Energypac Fashions Ltd-2

23th January 2018

Observations

Foundation layout plan

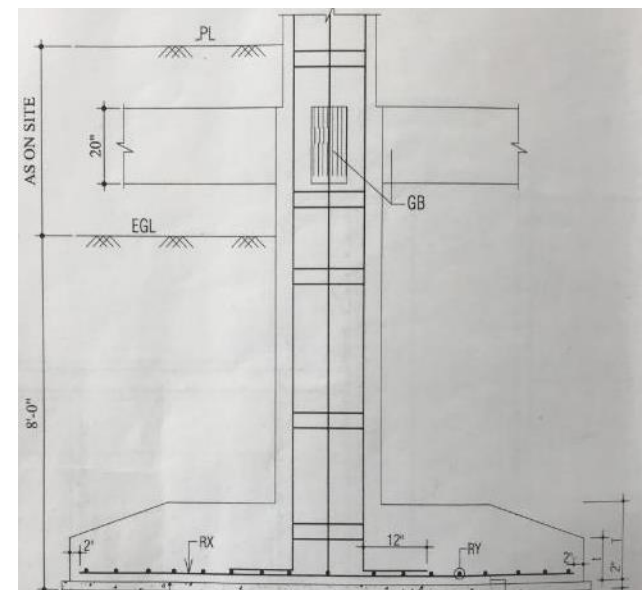
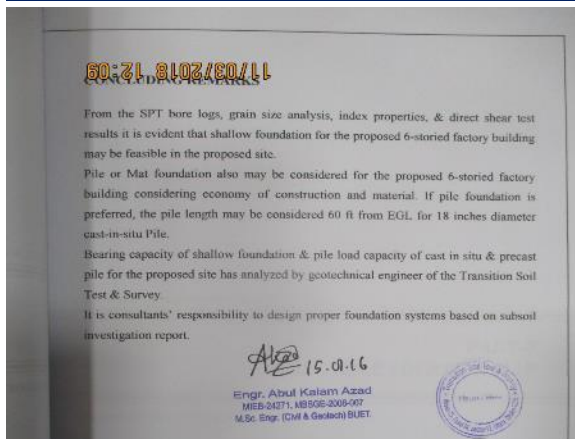
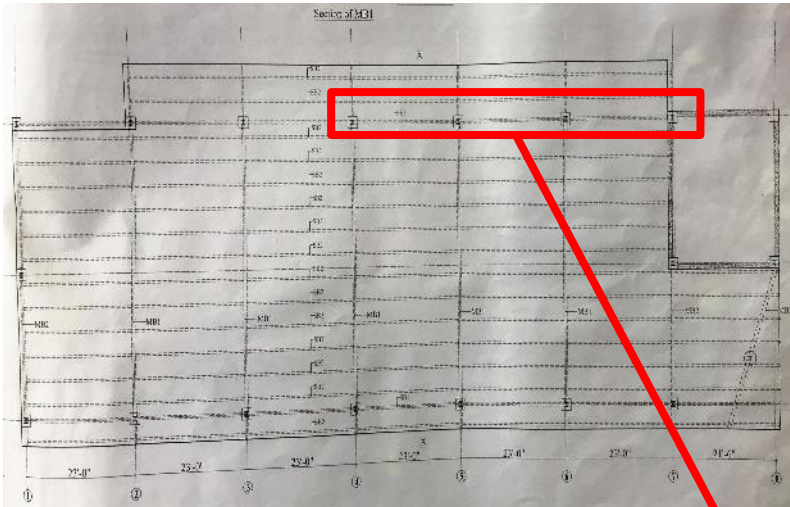
Design check required for the foundation system

Cursory calculation indicates that footing appears to be stressed above normal design limits in marked zone. Factory engineer is required to review the adequacy of footings considering actual depth of footing and comply with BNBC.

Beam layout plan of roof top shed

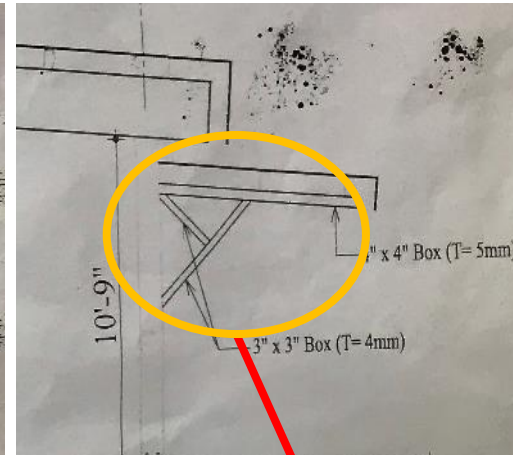
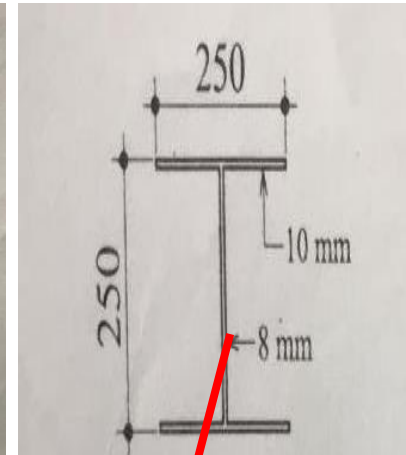
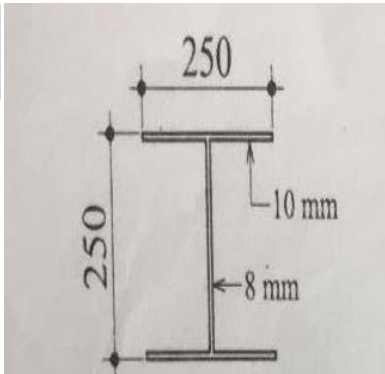
In place of box knee bracing, pipe knee bracing has been installed.

In place of 100mm X 100mm box section, 200mm X 100mm I-section has been provided as beam adjacent to the knee bracing.

Also, column Section were found to be tapered in stead of regular I-section shown in provided drawing

Beam layout plan of roof top shed

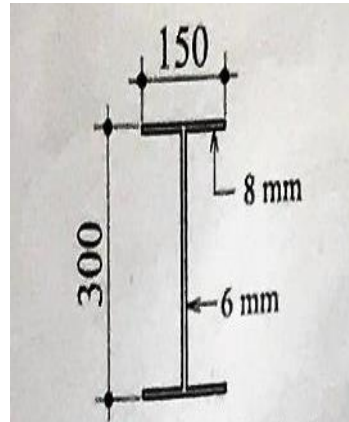
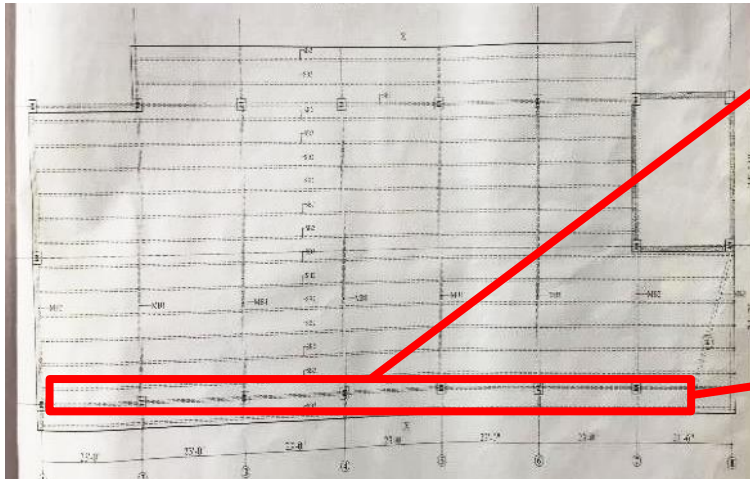
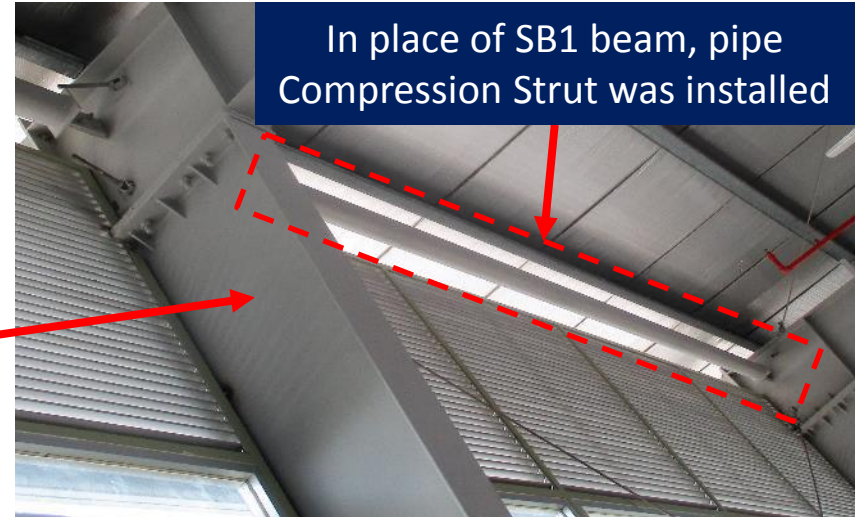
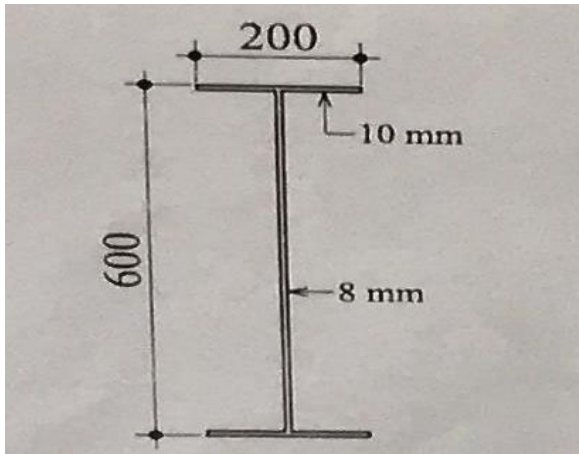
In place of SB1 beam, pipe
Compression Strut was installed

All the columns installed in the roof shed were found to be tapered sections where as uniform I-section is shown in the provided drawing

Beam section MB1

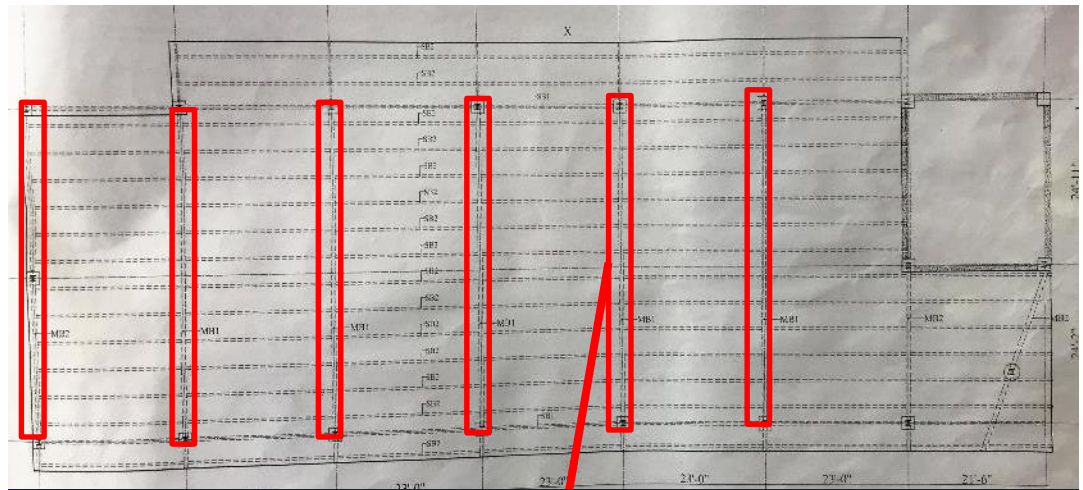
All the rafters are in three parts connected by bolts. Two end sections of rafters are tapered sections which were shown as uniform I-section in the provided drawing.

5th Floor Beam Layout Plan

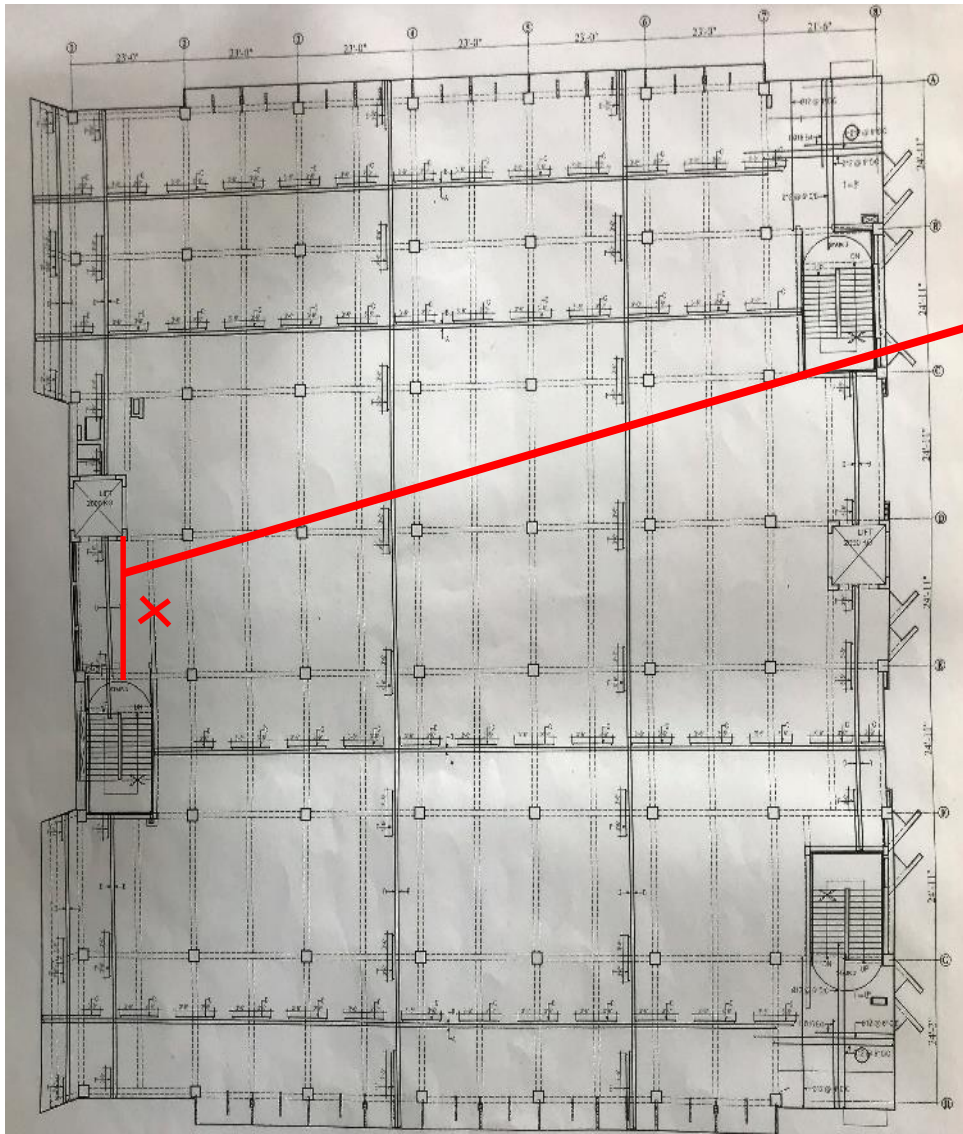
5th Floor beam layout does not match
with provided beam layout plan. Beam
B5 was found 2.3 m offset towards west
from grid 2-DE which is showed in
provided drawing

Opening in slab due to conveyor facilities

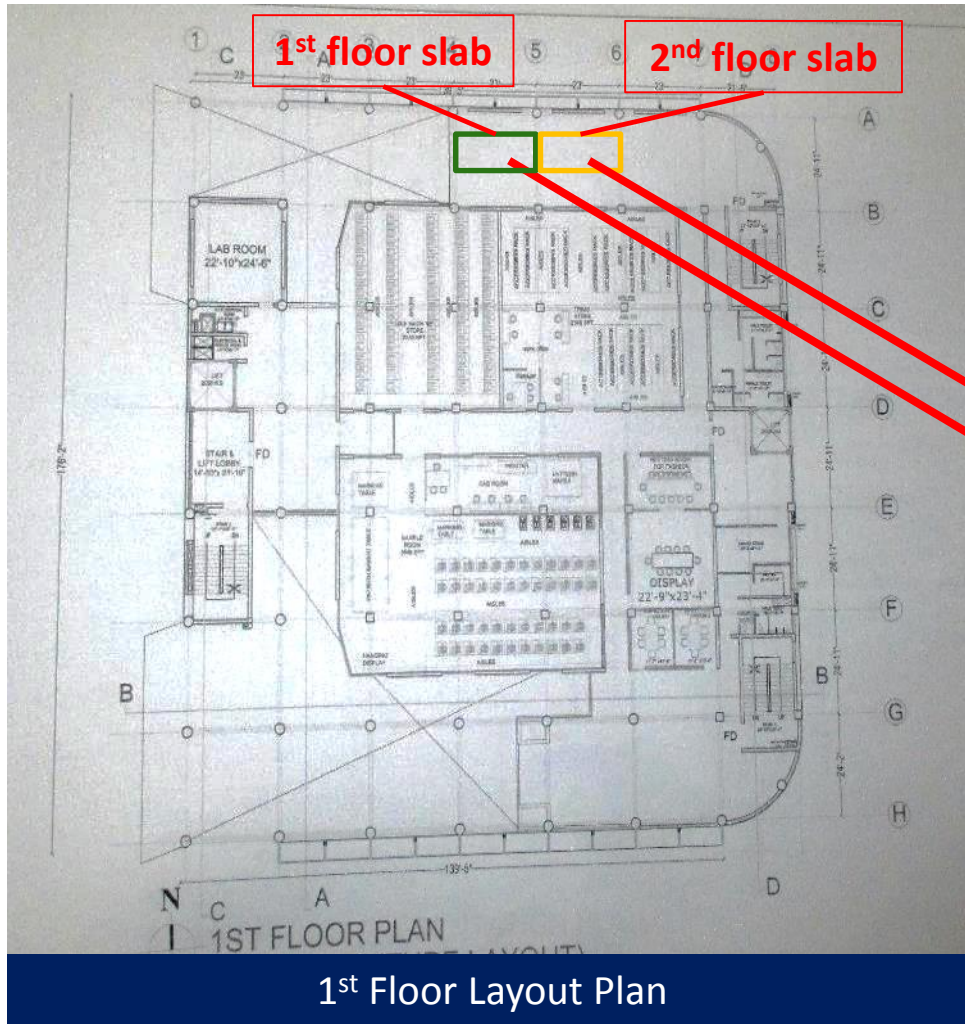
There are openings on 1st (Grid A-B & 4-5) and 2nd (Grid A-B & 5-6) floor slabs for accommodating conveyor which are not shown in floor layout. Also, there are two beams on either side of the void which are not shown in beam layout.

1st Floor Layout Plan

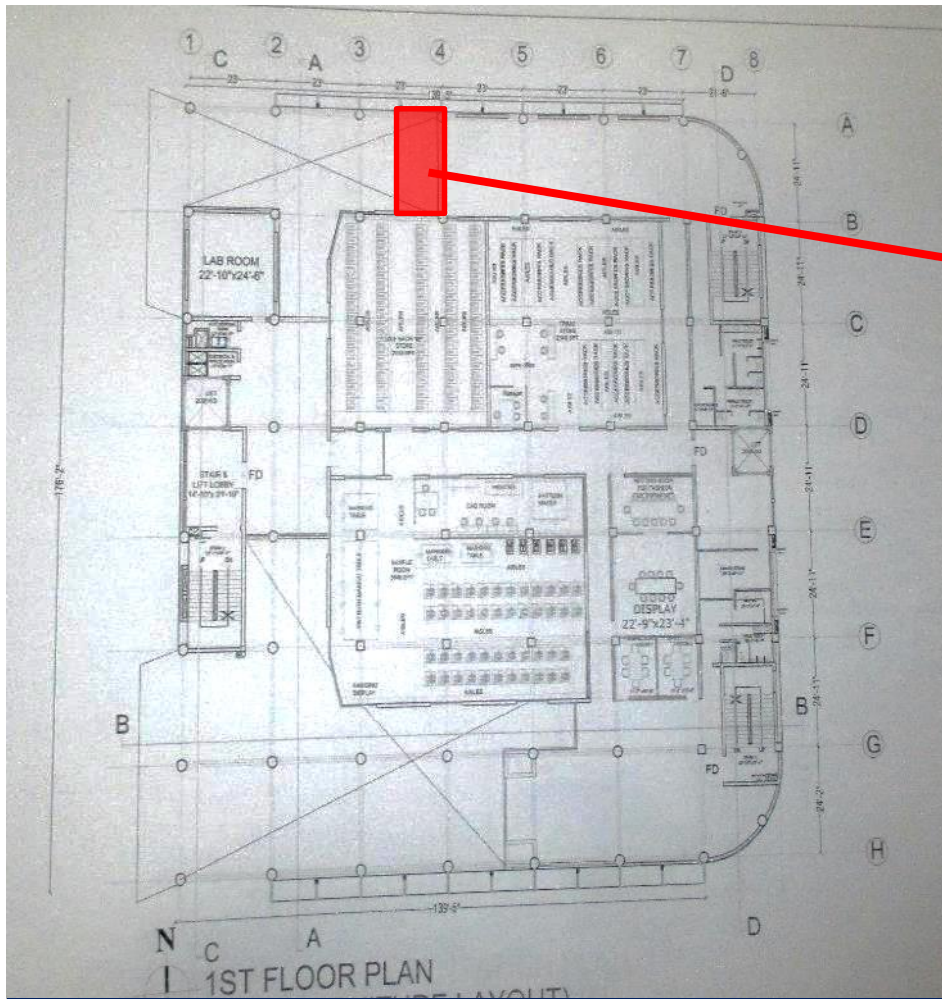
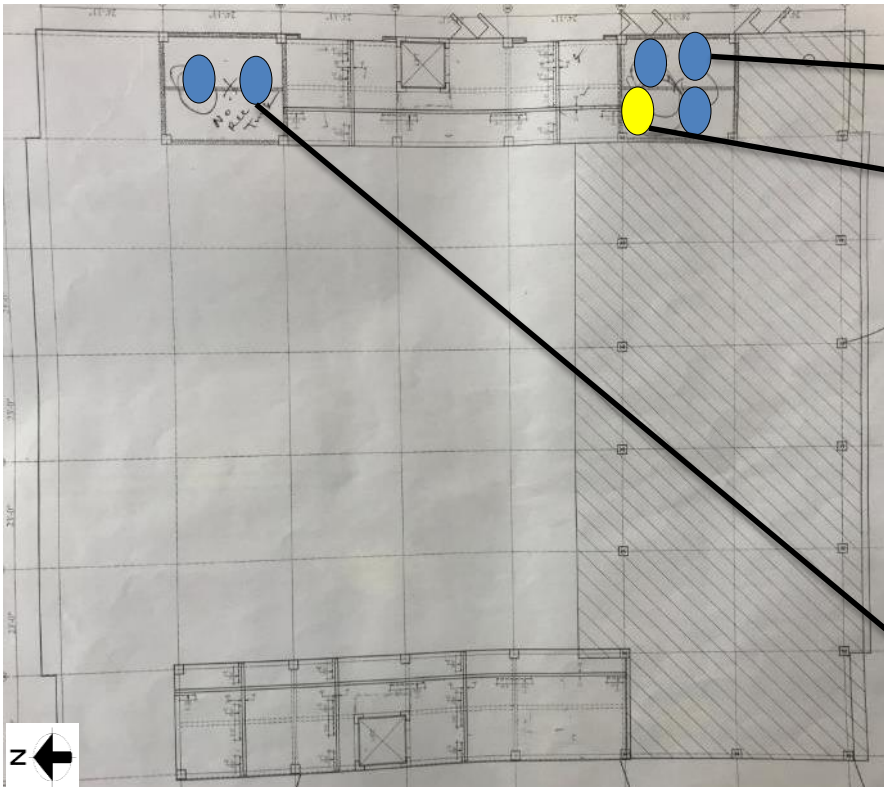
1st floor slab was extended by 7.5 m x 3.3 m in between grid A-B & 3-4.

Roof plan layout

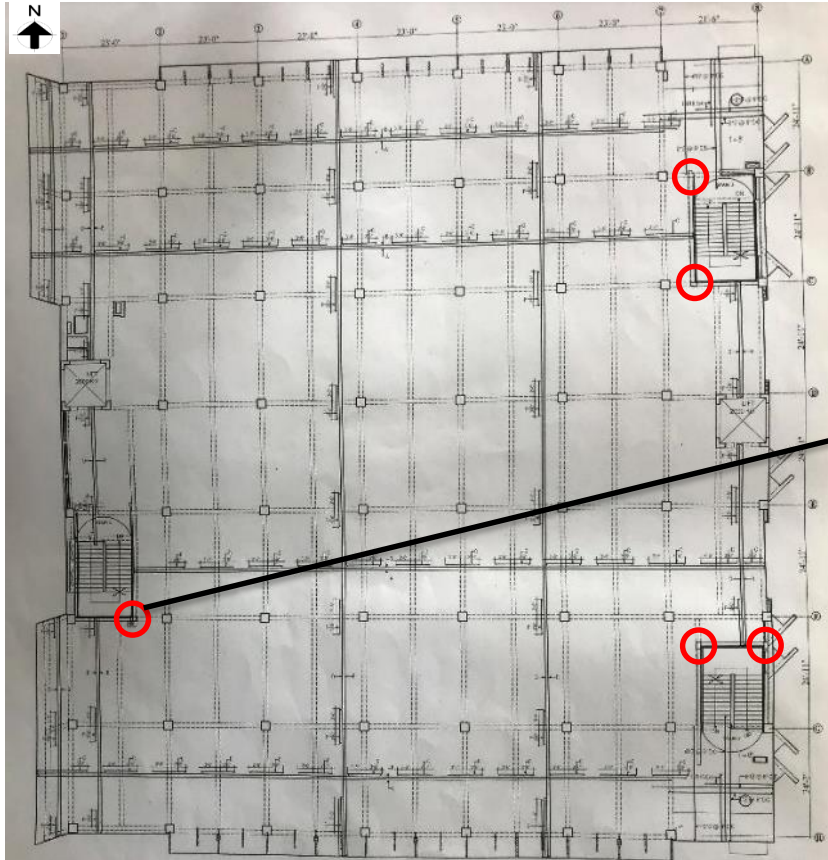
Three nos. 10000 liter and single 5000 liter water tank on stair case roof slab

Two nos. 10000 liter water tank on stair case roof slab

Concerns on the roof slab supporting 10000 Liter water tanks. A capacity check of these slabs and all related elements need to be carried out.
